TECHNICAL SERVICE BULLETIN

TSB-OT-0019 REV1

Date: April 05, 2022
To: Internal, Sales, Distribution, and Sales Representatives
From: Jimmy Trusty - Product Specialist
Subject: Revision - 5-Ton Rooftops DFG/DFC Missing Valve Cores in Pressure Switches

Image 1
Valve Core Omitted

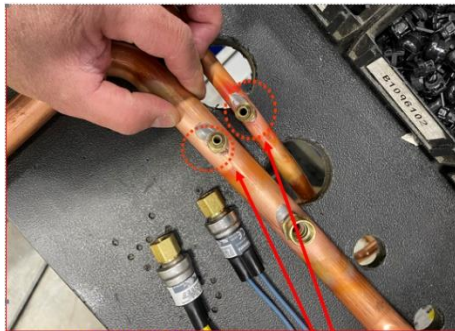
It has come to our attention that the new 1- and 3-phase, 5-ton gas/electric and air conditioner rooftop units (RTU), models DFG and DFC, are missing the valve cores in the low-pressure and high-pressure switch assemblies (see Image 1 below).

A valve core or tee must be installed per the instructions below using kit CPSKT01. Failure to follow these instructions could result in injury and complete loss of charge.

Image 2
Valve Core Installation

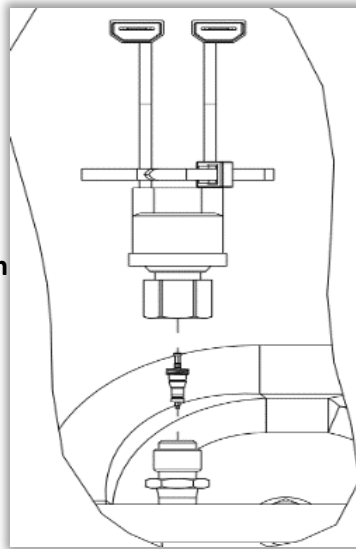
3. Once the refrigerant has been recovered, remove the low-pressure and high-pressure switches.
4. Determine if the valve core fits into the existing fitting as shown in Image 2 below.

1. Install the valve core (refrigerant rated) Daikin part number B1787000 supplied in kit CPSKT01 in each fitting, torquing to 4 +/- 1-inch lbs. See Image 2 below.

Image 3
Tee Adaptor

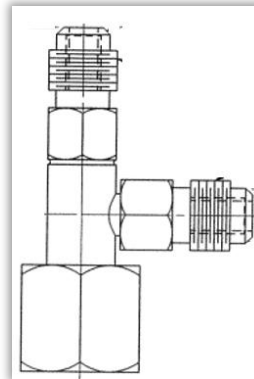
1. If the valve core does not properly fit into the existing fitting, install the tee adaptor supplied in kit CPSKT01 and follow the steps below. See Image 3 below.

2. Add thread sealer, provided in kit CPSKT01, to the threads of the fitting.
3. Install the tee torquing to 96 +/- 5 inch lbs. Use a back-up wrench to hold the fitting to prevent twisting and leaks at the braze joint.
4. Install the low-pressure switch on the suction line and high-pressure on the discharge line torquing each switch to 96 +/- 5 inch lbs. Use a back-up wrench to hold the fitting to prevent twisting and leaks at the braze joint.
5. Install the valve cap, supplied in kit CPSKT01, on the unused side of the tee.
6. Place the warning label around the suction and discharge lines next to the tee.
7. Evacuate the unit to 500 micron and hold.
